**HOLTEC INTERNATIONAL**

**HI-STORM 100 CERTIFICATE OF COMPLIANCE 72-1014**

**CERTIFICATE AMENDMENT REQUEST 1014-1**

## **SUMMARY OF PROPOSED HI-STORM 100 CHANGES<sup>1</sup>**

FIGURE 2.1-1  
FUEL LOADING REGIONS - MPC-24

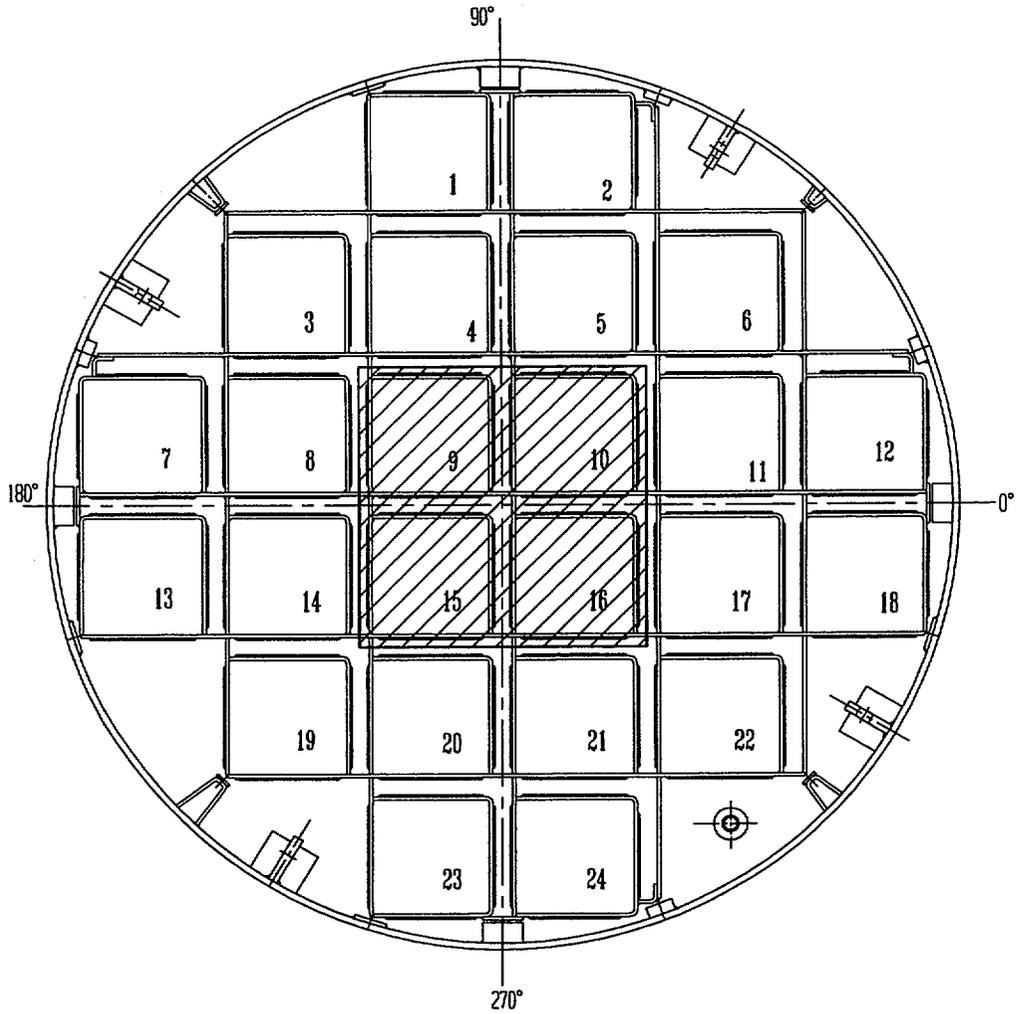
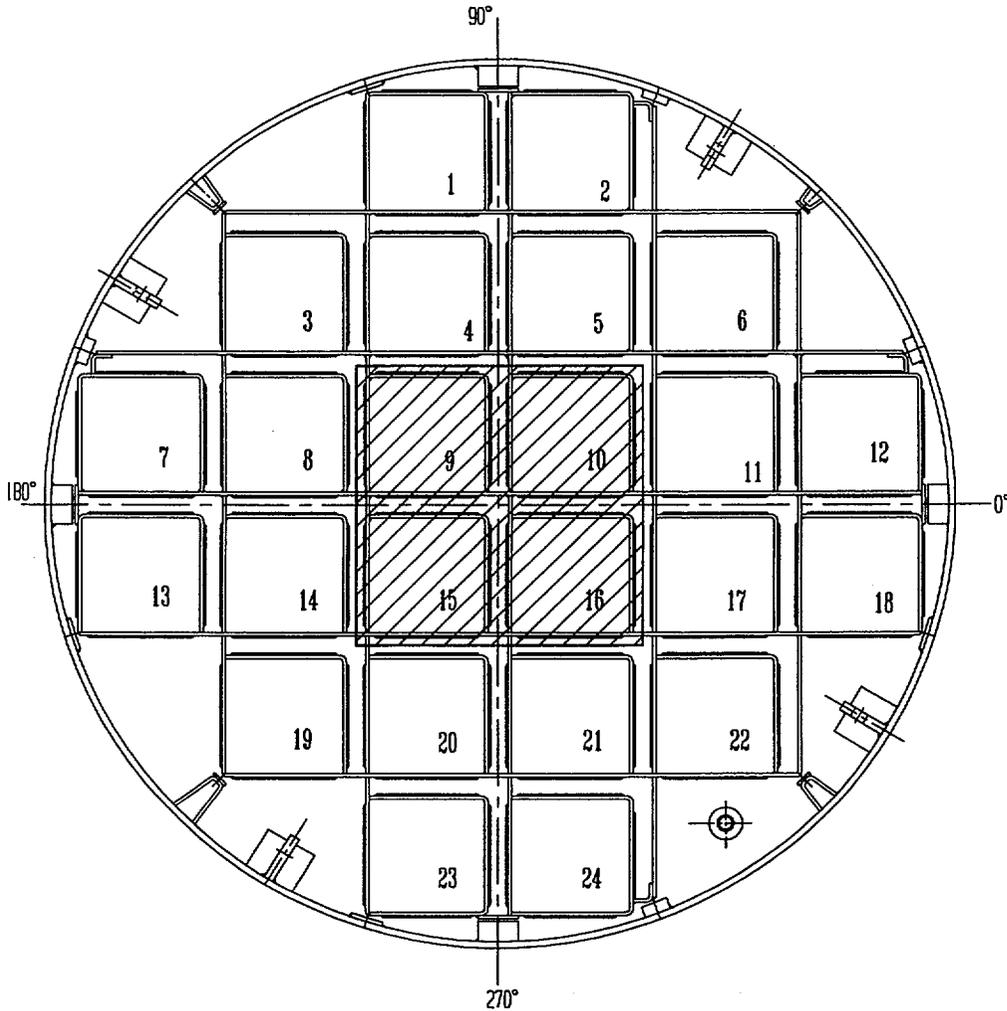
- b. New Subsection 2.1.3 and Figures 2.1-1 through 2.1-4 are added to introduce regionalized fuel loading as an option. Specific cooling time, burnup, and decay heat limits for regionalized fuel loading are specified in Tables 2.1-6 and 2.1-7 in the Approved Contents section of Appendix B to the CoC.

- a. Clarification to distinguish between uniform fuel loading and regionalized fuel loading and to clarify that regionalized loading meets the intent of preferential fuel loading.
- b. Regionalized fuel loading, in accordance with Figures 2.1-1 through 2.1-4 and Tables 2.1-6 and 2.1-7, as applicable, allows users to load relatively higher heat emitting fuel assemblies than would otherwise be allowed using uniform fuel loading.

FIGURE 1.2.4A; MPC-24E/24EF CROSS SECTION VIEW

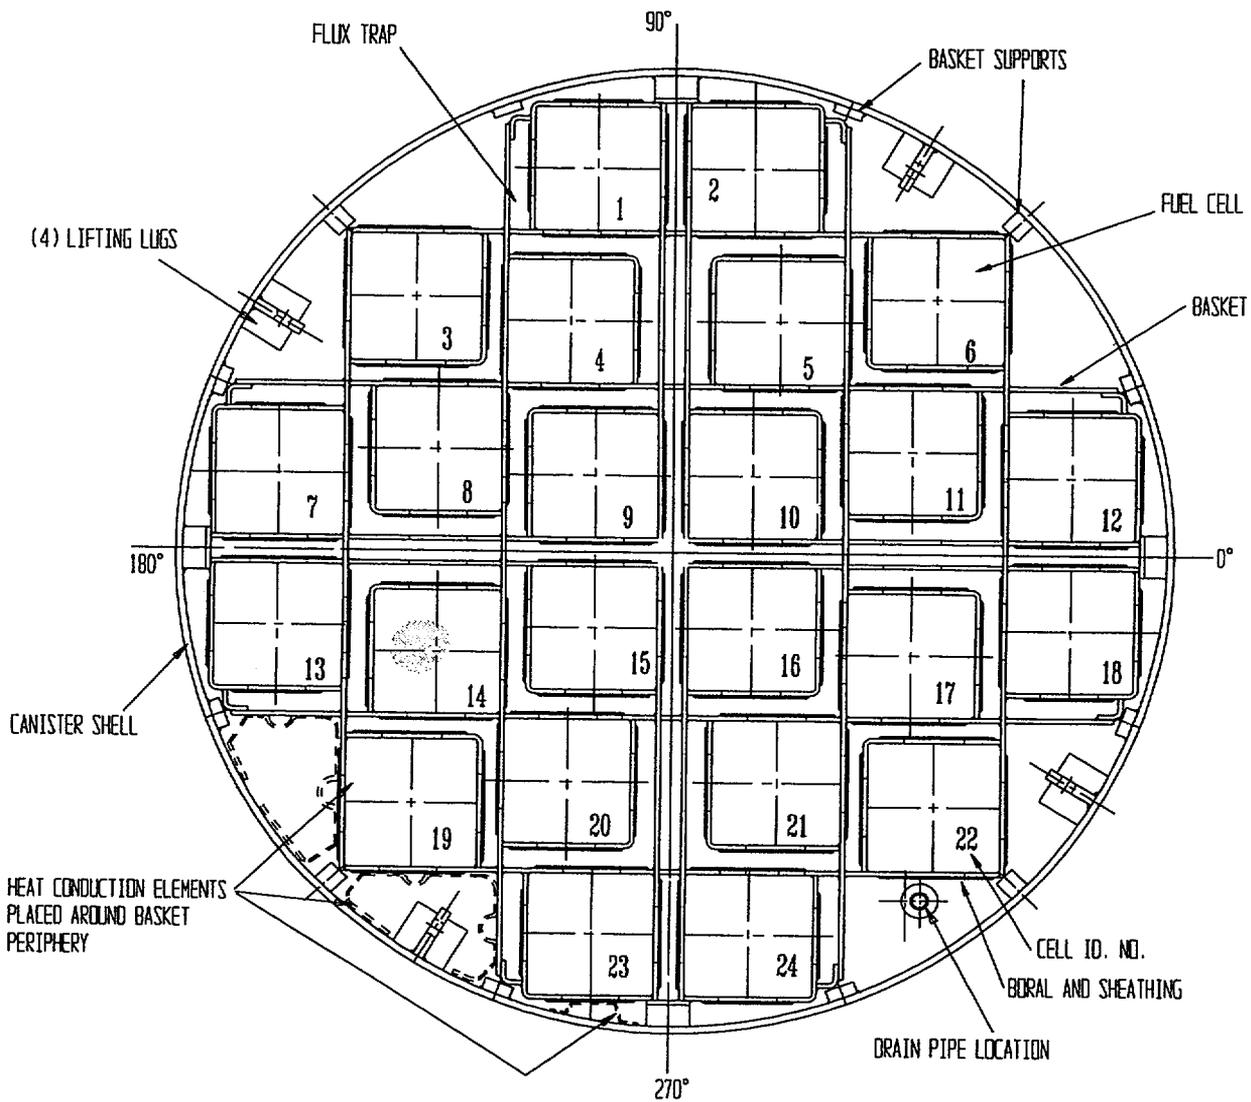
The MPC-24E is designed to accommodate up to twenty-four (24) PWR fuel assemblies, with or without non-fuel hardware. Up to four (4) fuel assemblies may be classified as damaged fuel assemblies, with the balance being classified as intact fuel assemblies. Damaged fuel assemblies must be stored in fuel storage locations 3, 6, 19, and/or 22 (see Figure 1.2.4A).

*The MPC-24EF is designed to accommodate up to twenty-four (24) PWR fuel assemblies, with or without non-fuel hardware. Up to four (4) fuel assemblies may be classified as damaged fuel assemblies or fuel debris, with the balance being classified as intact fuel assemblies. Damaged fuel assemblies and fuel debris must be stored in fuel storage locations 3, 6, 19, and/or 22 (see Figure 1.2.4A).*
